PLANNING ASSESSMENT REPORT – SYDNEY EASTERN CITY PLANNING PANEL

2017SCL060, No's 68-72 Railway Parade and 2-10 Oxford Street, Burwood

Report Author:	Burwood City Council
Date of Report:	Original: 1 June 2018 Amended: 19 July 2017 (amended for solar access additional information – see page 6-8)
Property Address:	68-72 Railway Parade and 2-10 Oxford Street, Burwood
Proposal:	Development Application No. 124/2017 – Demolition of existing structures and construction of a six to ten storey mixed use development comprising 124 apartments, one retail premises at ground floor, and three levels of basement car parking.
Applicant:	X-Sealant Pty Ltd
Zone:	R1 – General Residential – Burwood Local Environmental Plan (BLEP) 2012

Figure 7. Marked up 1pm mid-winter shadow diagram indicating that large portions of the principal areas of playground will receive sunlight during typical lunch time hours (Source: Alexander Design Group, 2018; Marked: James Arnold, 2018)

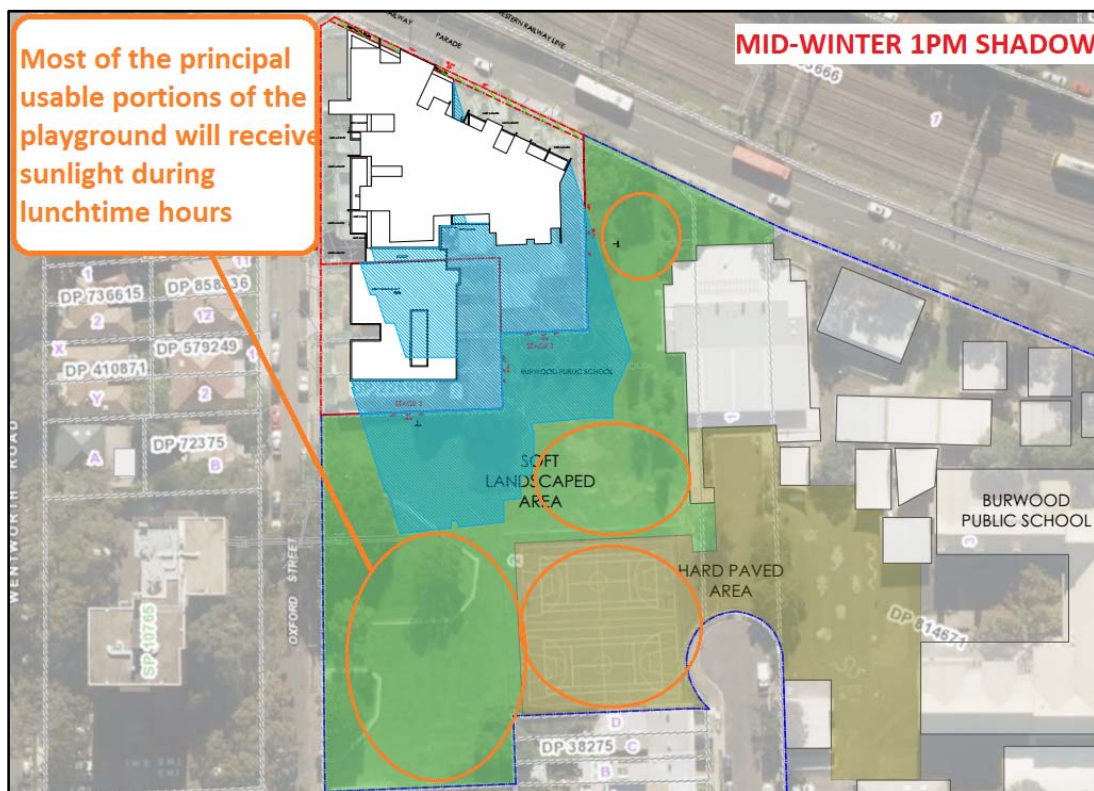
sunlight in mid-winter and the multi-purpose courts will be unaffected – see **Figure 7** below demonstrating this on the 1pm shadow diagram. This will ensure that during recess and lunch, at the worst time of year for sunlight, the majority of the principal usable parts of the playground will receive sunlight. Furthermore, the shadow impacts will be mostly limited to the northern/western part of the playground adjacent to the development site with the large southern portion including the multi-purpose courts being unaffected year-round.

Figure 17. Ground Floor Plan diagram showing the proposed condition to consolidate the two bin rooms and improve accessibility.

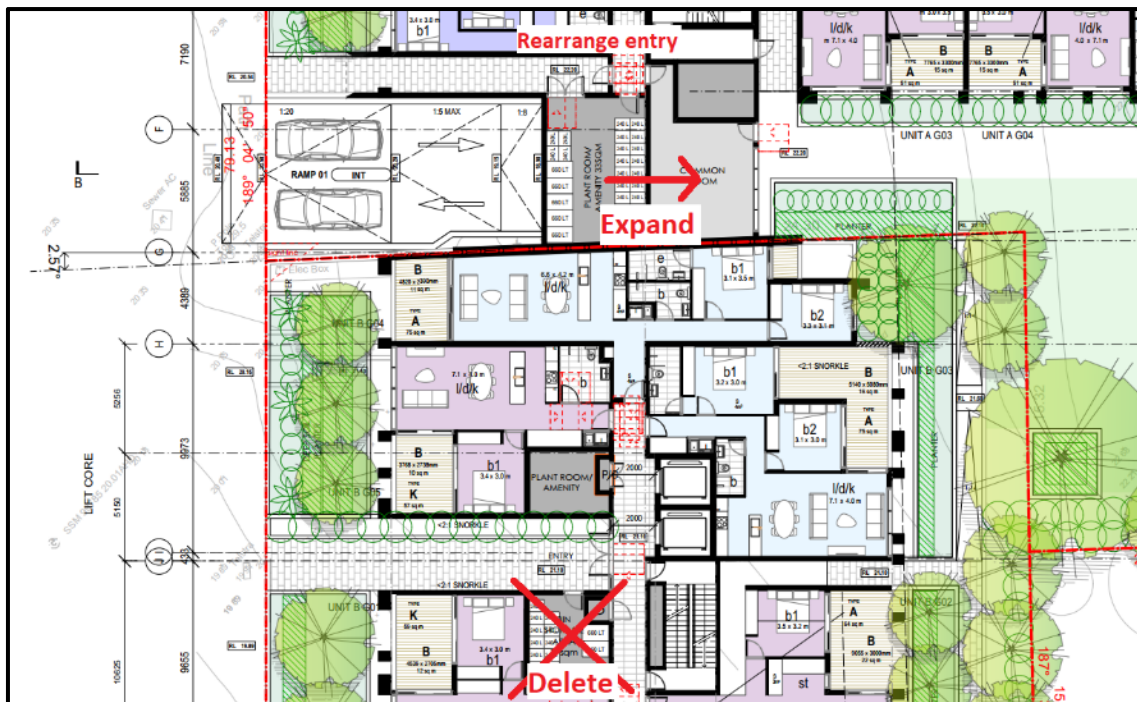
The amended proposal has deleted the bin area adjacent to the street and replaced it with two separate internal bin rooms at ground floor within Stage 1 (north) and Stage 2 (south). The revised arrangement is not supported as having two separate bin rooms will be inconvenient for transfer and collection of bins and the rooms provided are not easily accessible from the street.

To resolve this issue, there is scope to consolidate the bin rooms by expanding the northern bin room and deleting the southern bin room. The northern bin room can be expanded into the adjacent common room which can be relocated to the roof top communal space. The rooftop is considered a more desirable location for the common room as it will receive better solar access and natural ventilation as compared to this dark and poorly located ground floor space. To ensure the bin room facilitates easy transfer and collection of bins, the entry doors will also need to be rationalised and widened. This revised temporary bin storage room has been conditioned as below and the intended effect is illustrated in **Figure 17**.

Condition – The southern temporary waste bin storage room on the ground floor is to be deleted and the northern ground floor waste room expanded commensurately. The northern waste room is to be expanded into the adjacent common room and the entry area to the new room is to be rationalised to allow for wide and easy access for the transfer of bins in and out of the room. The common room is to be relocated to the rooftop communal area and is to have minimum dimensions of 4m. The space of the southern bin room may be incorporated into the adjacent apartment.

Figure 19. Marked amended northern elevation showing the stepped down bulk to minimise impacts on adjoining school (Source: Alexandar Design Group, 2018 / Marked: James Arnold, 2018)

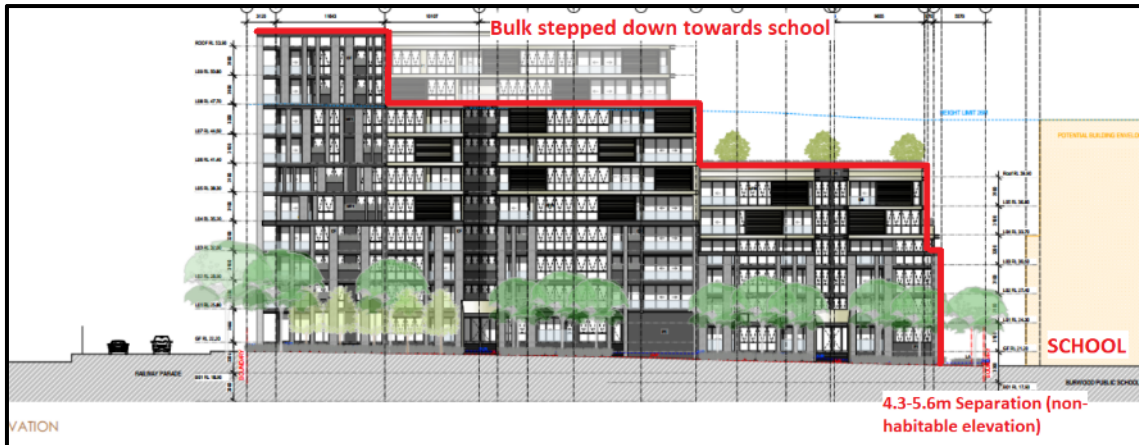
In response to Council's requests, the applicant submitted a significantly revised proposal which shifted the bulk and height of the development to the north of the site, allowing for a reduced built form of 6 storeys adjacent to the school in the south of the site. The amended built form as viewed from Oxford Street is shown in **Figure 19**. As part of the amended set of plans, overshadowing diagrams compare the shadows of the originally submitted proposal to the amended proposal. These diagrams indicate significant improvements for solar access to the adjoining playgrounds. It is estimated that at the worst time of year for solar access (June 22) that the adjoining playgrounds will receive direct sunlight to at least 50% of the space throughout the day between 9am and 3pm. During the key times of 11am to 1pm when the playgrounds will be most heavily utilised, the diagrams indicate shadowing to only a minor portion near the boundary with the site. The middle of the playground and the multi-purpose courts will be mostly unaffected during those hours. The primary portions of the playground are shown in **Figure 20**.

Figure 20. Aerial image of the site and the adjoining school playgrounds. The primary portion of the playgrounds is identified (Source: maps.google.com.au / Marked: James Arnold, 2018)

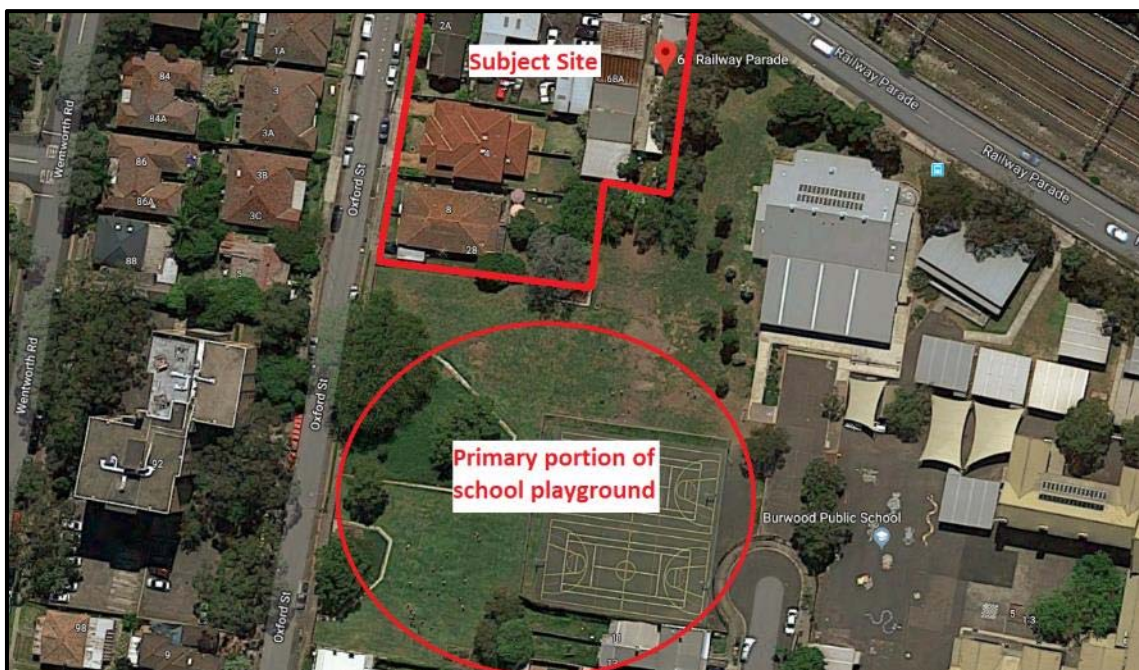
In considering the appropriateness of overshadowing impacts on the school playgrounds, there are no specific planning controls that are applicable. Accordingly, the impacts have been assessed on a merit basis. Having consideration for the impacts that would be anticipated from the development controls that apply to the subject site and the amendments to the built form that have been undertaken to minimise those impacts, the overshadowing impact is considered acceptable.

Figure 21. Marked floor plan showing separation distances from habitable areas to boundaries and views to the main part of the playground will be cross views and obstructed by vertical fins (Source: Alexandar Design Group, 2018 / Marked: James Arnold, 2018)

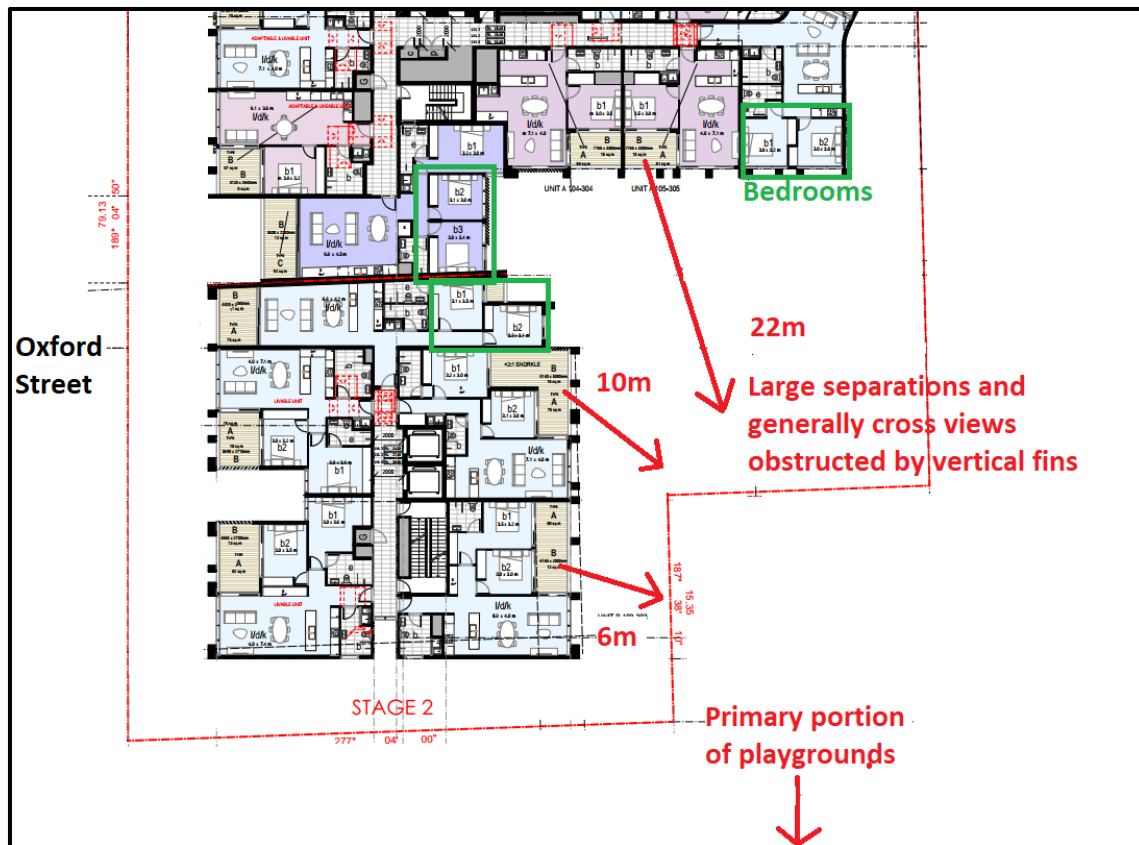
When considering privacy impacts, the applicable planning controls for this development are provided in the Apartment Design Guide. Privacy is primarily achieved via separation distances from apartments to the boundaries. The proposal complies and significantly exceeds the ADG requirements which stipulate a minimum 3m separation from non-

habitable openings to boundaries and 6m from habitable openings to boundaries. The habitable areas and separation distances from the apartments that face the school boundaries to the south and east are shown in **Figure 21**. As shown, the minimum distance is 6m for only six apartments in the southern portion of the building. The remaining apartments are separated by 10-22m from the boundary and any views to the main portion of the adjoining school playground are cross views and highly obstructed by the vertical fins proposed on the facades of the building.

Given the above, the proposal achieves and generally far exceeds the applicable privacy provisions. Overlooking from the development to the adjoining school playgrounds has been minimised as far as practical and as such is considered to be acceptable.
